Avon Advisory Planning Commission Meeting  
**Monday, February 23, 2026** at 6:30 pm  
at Avon Town Hall

Planning & Building Department Staff Report

<b>A. PETITION NUMBER</b>	DPR 25-12: 267 Park Place Crossing
<b>B. APPLICANT</b>	Tranquility, LLC, by Kruse Consulting, Inc.
<b>C. LOCATION</b>	56, 82, & 108 Park Place Boulevard (approximate addresses)  Lots 5, 6, & 7 in Avon Park Place
<b>D. PARCEL SIZE</b>	1.68 acres
<b>E. LAND USE &amp; ZONING</b>	The site is undeveloped, is zoned C-2: General Commercial District, and located within Tiers 1 & 2 of the U.S. Highway 36 Zoning Overlay.
<b>F. ACTION REQUESTED</b>	Request for approval of a Development Plan Review to allow for construction of a one-story, multi-tenant commercial building with surface parking and related improvements.
<b>G. HISTORY</b>	<p>The site was platted and recorded in 1988 under the jurisdiction of Hendricks County.</p> <p>This petition was discussed at the September 18, 2025 Technical Advisory Committee (TAC) meeting, and accordingly docketed for the October 27, 2025 Plan Commission (PC) meeting. The petition was continued to the December 22, 2025 meeting, and then to the January 26, 2026 hearing to allow for th

## Exhibit B2 – Revised Site Plan (6-Feb-2026)

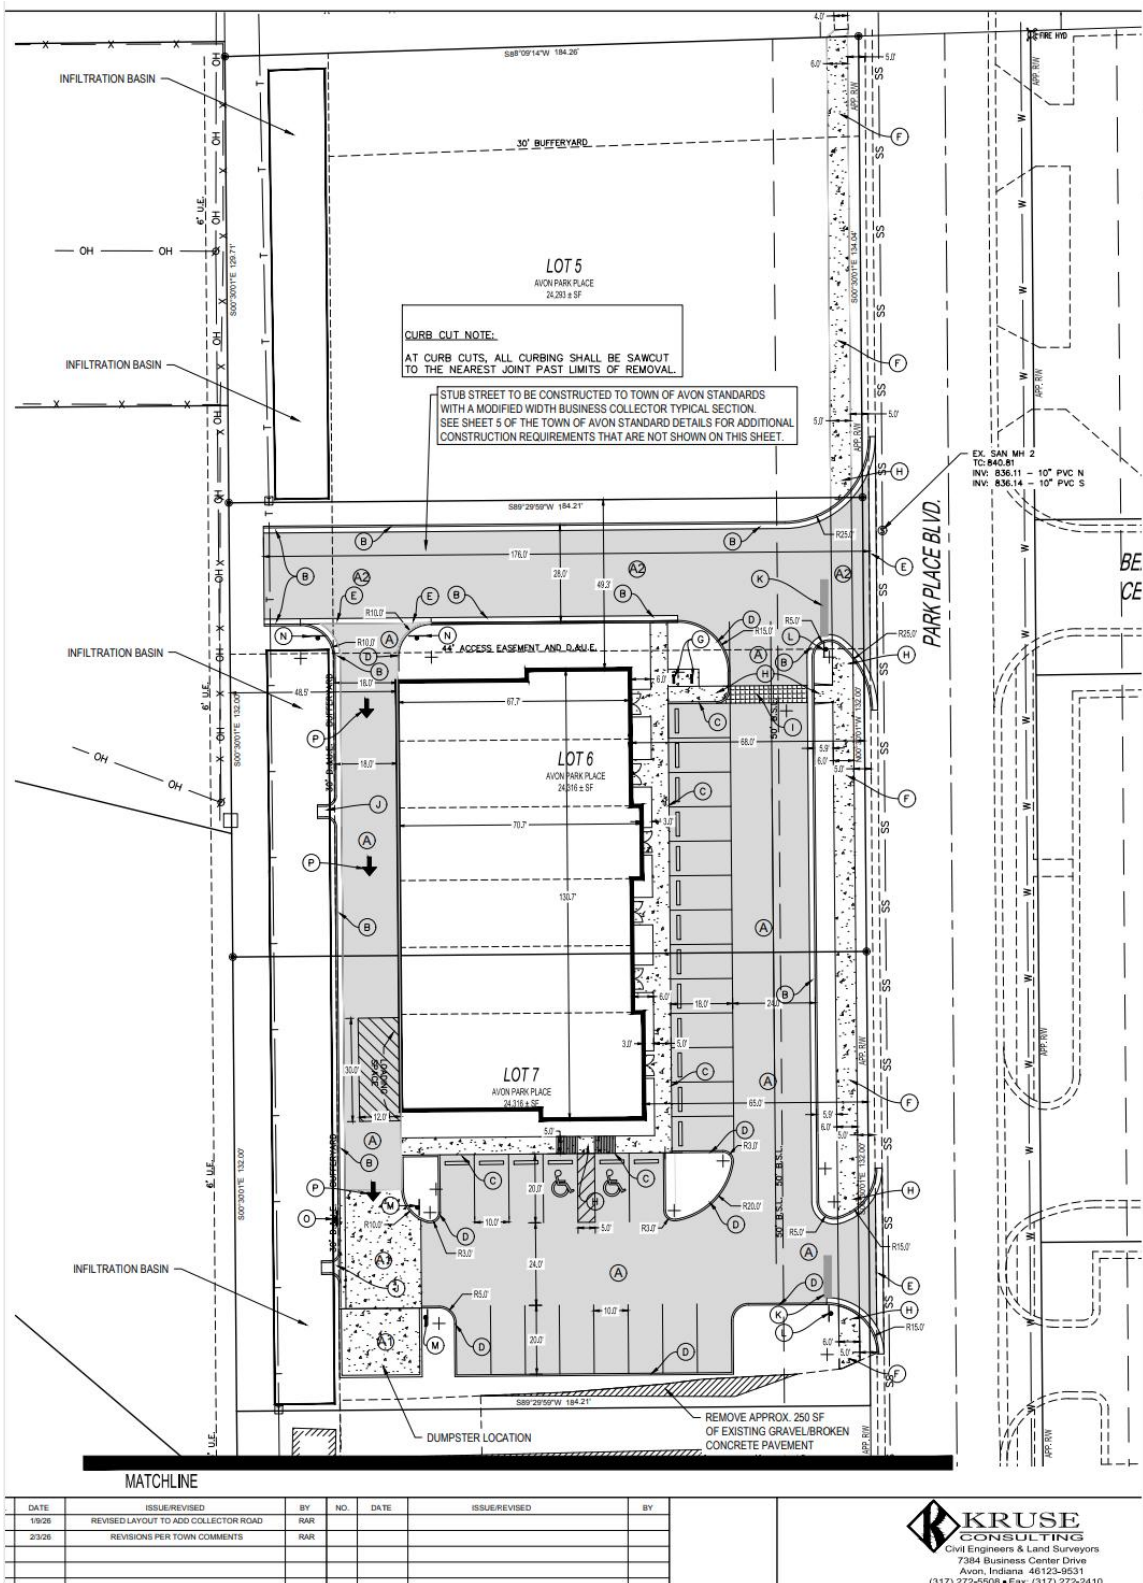
a) **Parking:** The site plan proposes 27 spaces. UDO Table 6.3 specifies the required amount of off-street parking based upon the type of commercial use that occupies each building, such as two (2) spaces per 1,000 square feet of Gross Floor Area (GFA) for general office use, two and one-half (2.5) spaces per 1,000 for retail sales, and five (5) parking spaces per 1,000 for restaurants or taverns. The proposed three (3) spaces per 1,000 square feet of GFA would meet the requirement for either general office or retail uses. If permitted uses requiring additional parking are proposed in the future, additional parking could be required at that time.

b) **Loading:** A loading space, as required, is identified on the site plan at the rear of the building in a location that does not prevent ingress/egress to any parking areas.

Waiver: A waiver of development standards of UDO 2.10(M)(1) to provide for a 16.9-foot front landscape buffer with sidewalk therein (minimum 20-foot front landscape buffer required).

Waiver: A waiver of development standards of UDO Table 6.1 to provide for a row of 18-foot deep off-street parking spaces (minimum 20-foot parking space depth required).

Waiver: A waiver of design standards of UDO 7.21(E) to provide for a full-access driveway onto Park Place Boulevard offset from two existing driveways on the opposite side of the street (minimum 150-foot separation required).

# Exhibit B3 – Revised Landscape Plan (6-Feb-2026)

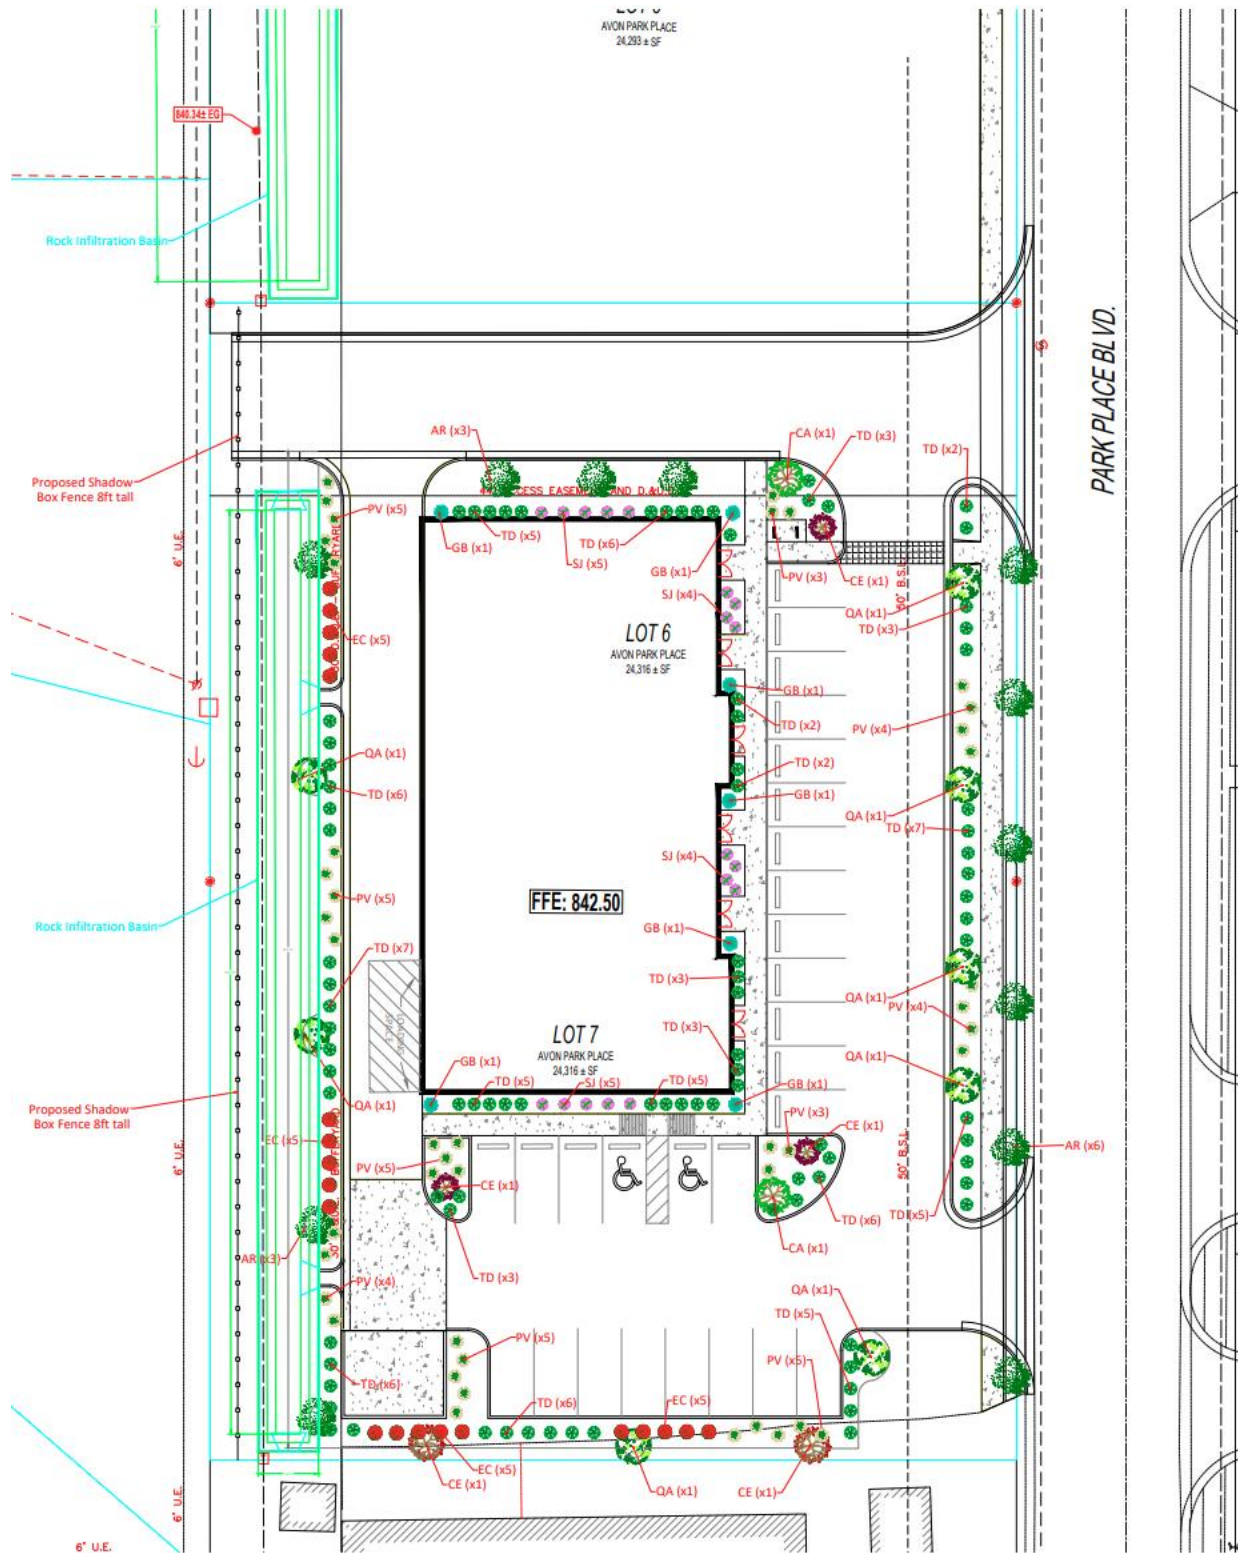
Except for Waivers B & D to reduce the front buffer yard and foundation planting areas, the proposed landscape plan appears to meet all other requirements of the UDO.

Waiver: A waiver of development standards of UDO 6.5(A) to provide for no foundation planting area adjacent to the west façade and a reduced width of foundation planting area along portions of the east façade (minimum 5-foot wide planting area required around the building except at loading areas and doorways);

# Exhibit B2 – Revised Site Plan (12-February-2026)

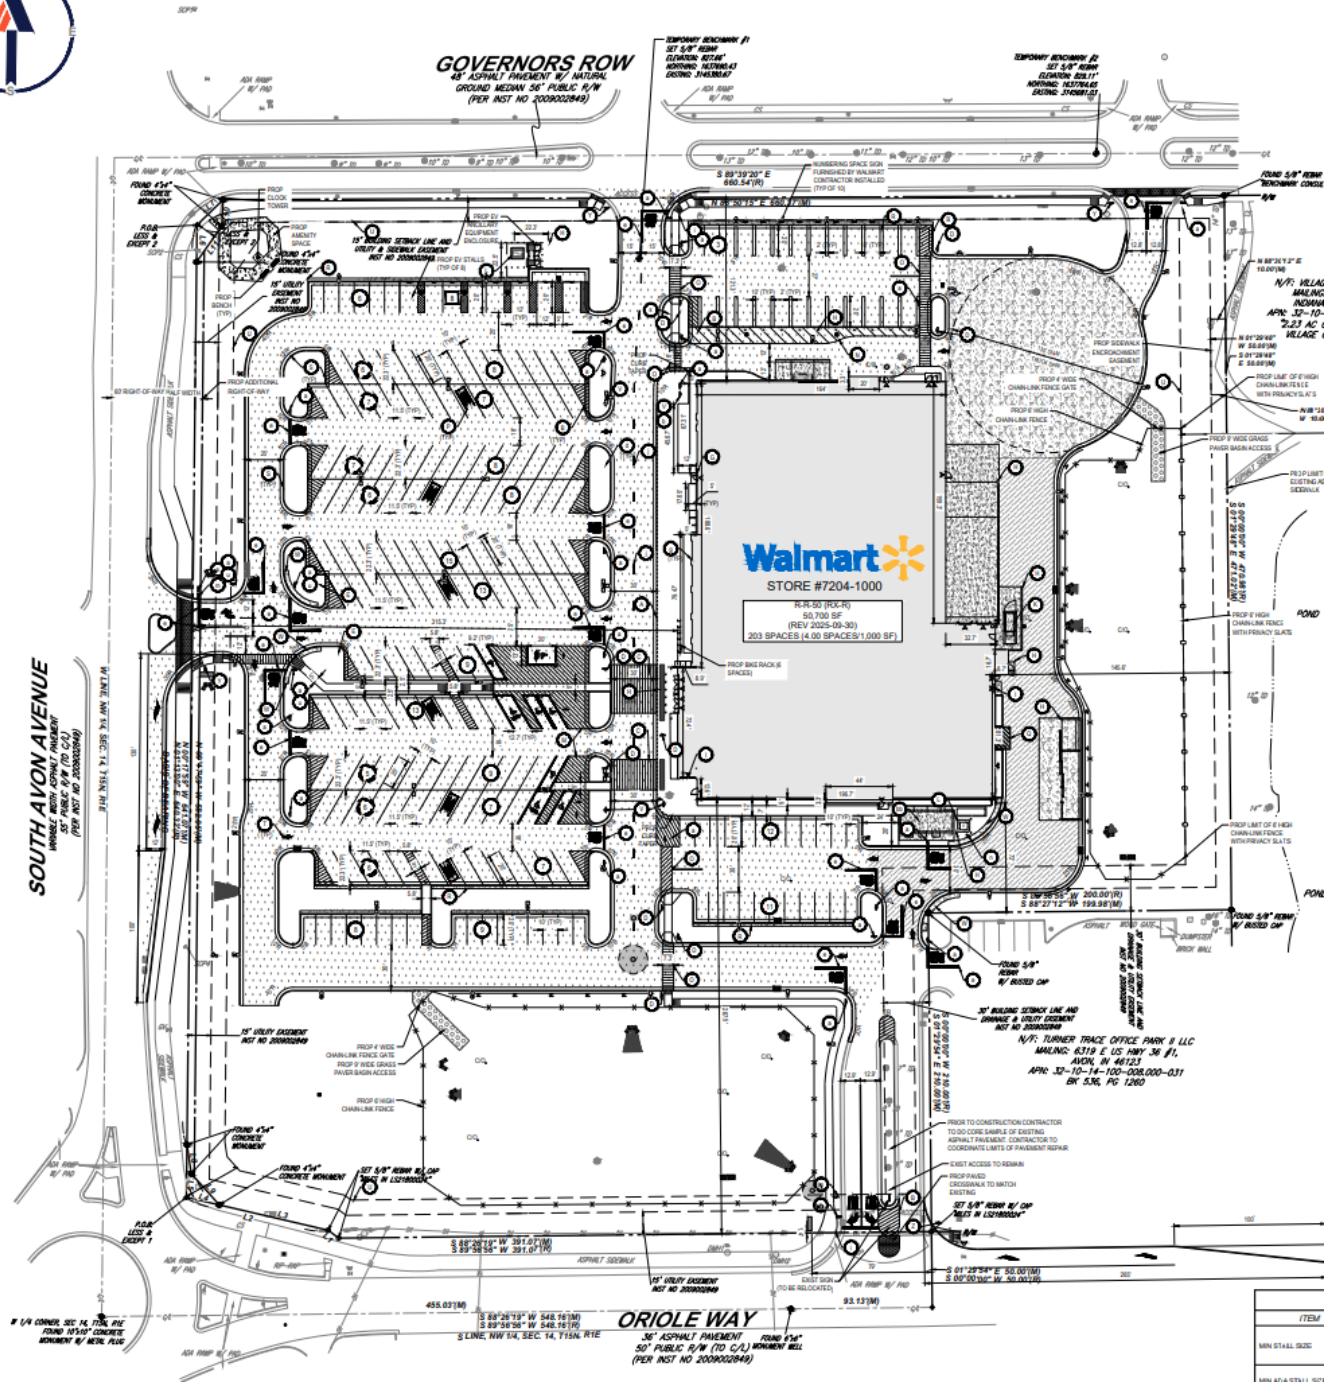
- a) **Parking:** The site plan indicates the provision of 225 off-street vehicle parking spaces, with eight (8) of those being reserved accessible spaces. UDO Table 6.3 specifies that a minimum of 2.5 spaces per 1,000 square feet of gross floor area for a grocery store or other retail use, thus, a minimum of 127 spaces would be required for the proposed 50,700-square foot store. Based on the overall number of spaces provided, a minimum of seven (7) reserved accessible spaces would be required.

- b) **Loading:** Retail buildings between 7,500 and 75,000 square feet are required to provide a minimum of one (1) dedicated loading space. The site plan indicates two (2) dedicated loading spaces meeting the spatial requirements for tractor-trailer deliveries.

- c) **Bicycle Parking:** The UDO requires one bicycle rack per every twenty (20) required vehicle parking spaces, thus, six (6) bicycle racks would be required. While the revised site plan shows bicycle racks in a compliant location, the plan only indicates five racks. At least one additional rack would be required.

# Exhibit C1 – Revised Landscape Plan (2-January-2026)

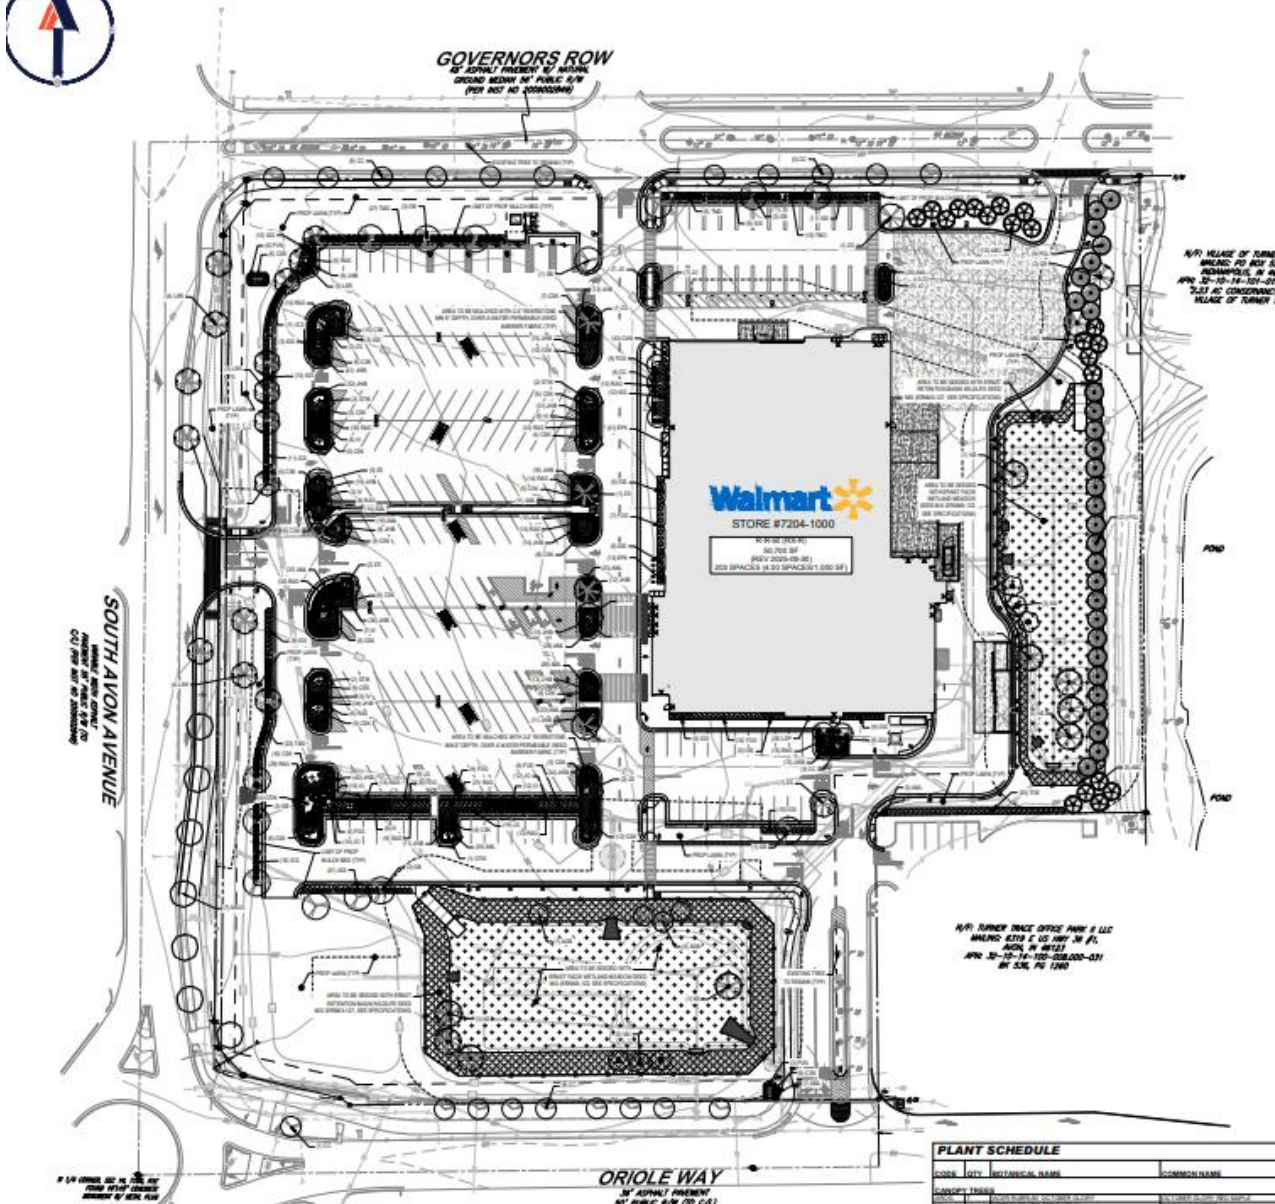
Per UDO 6.7(B)(4), each parking lot landscape island must have a minimum of one tree. The revised landscape plan is still deficient of this standard.

A further revised landscape plan should be submitted to demonstrate compliance with the foundation planting and interior parking lot landscaping requirements.

## Exhibit C2 – Areas Deficient of Foundation Planting Requirement

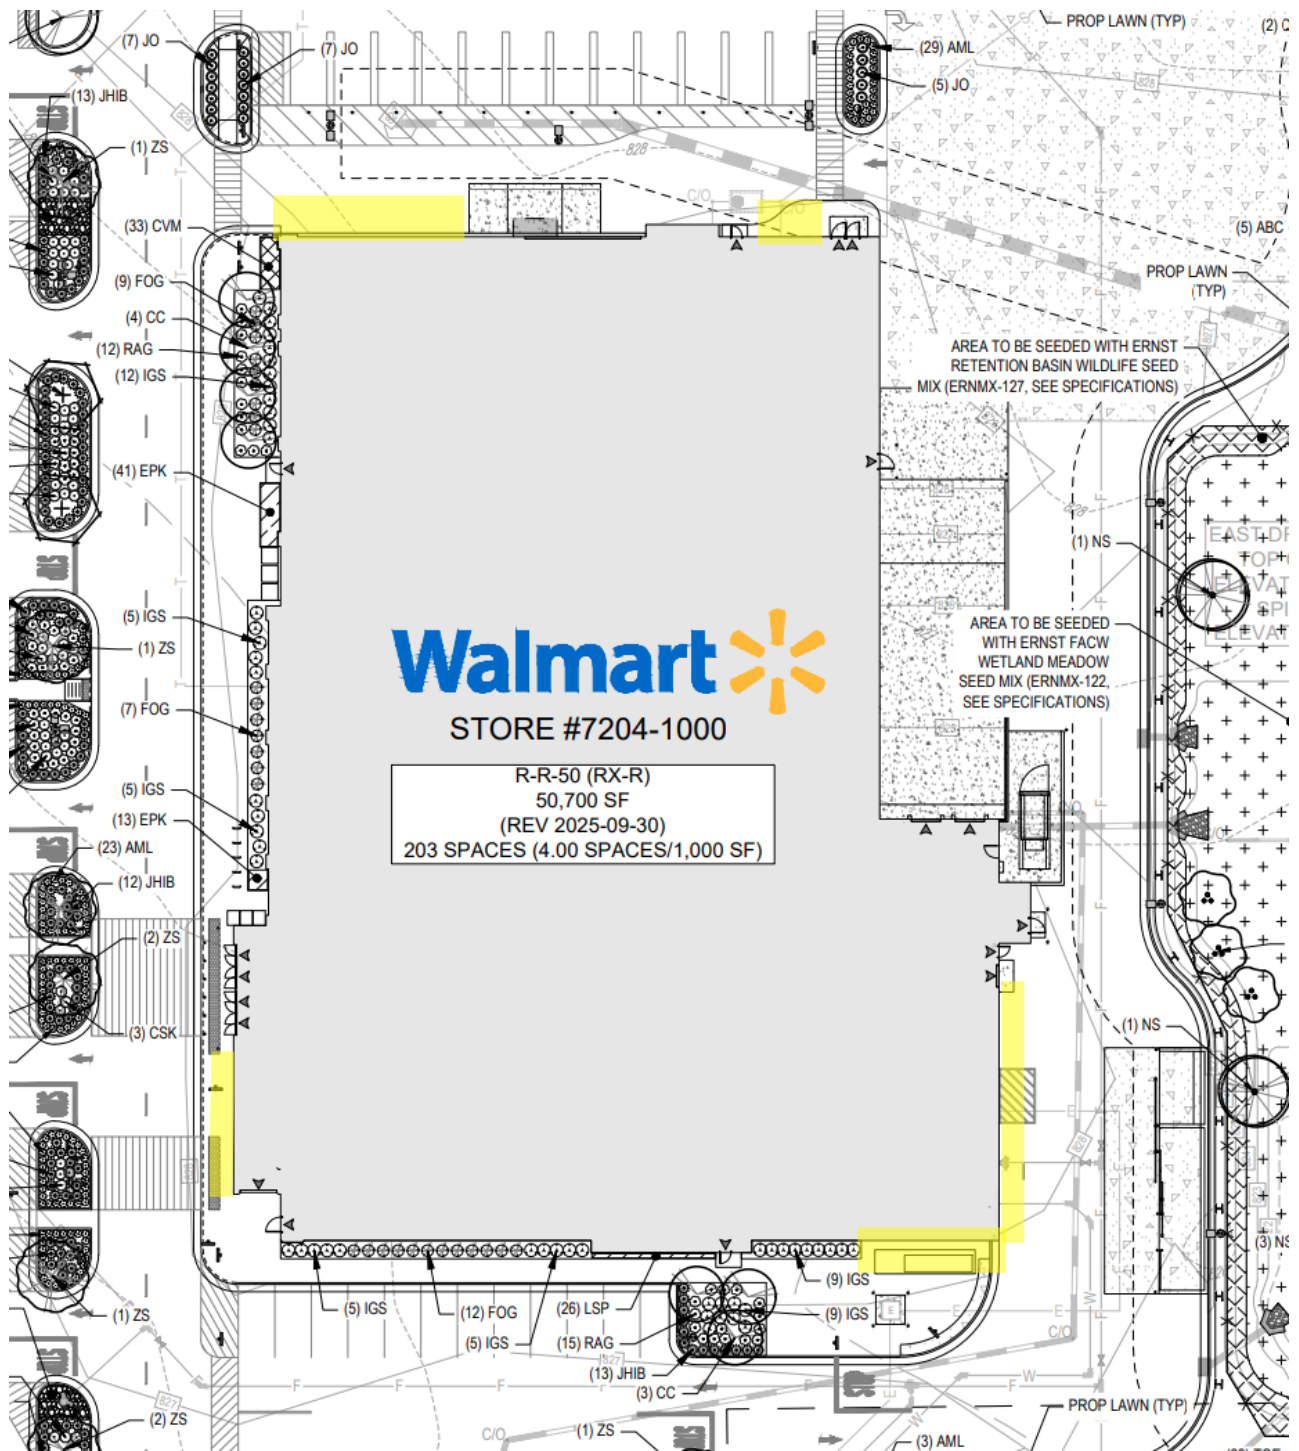
Per UDO 6.5 (A), a minimum five-foot planting area must be provided around the perimeter of the building, excluding access to the buildings, such as loading areas and doorways. The landscape plan submitted subsequent to TAC review has increased the proposed foundation planting areas, but is still deficient along several portions of the building (see Exhibits C1 & C2).
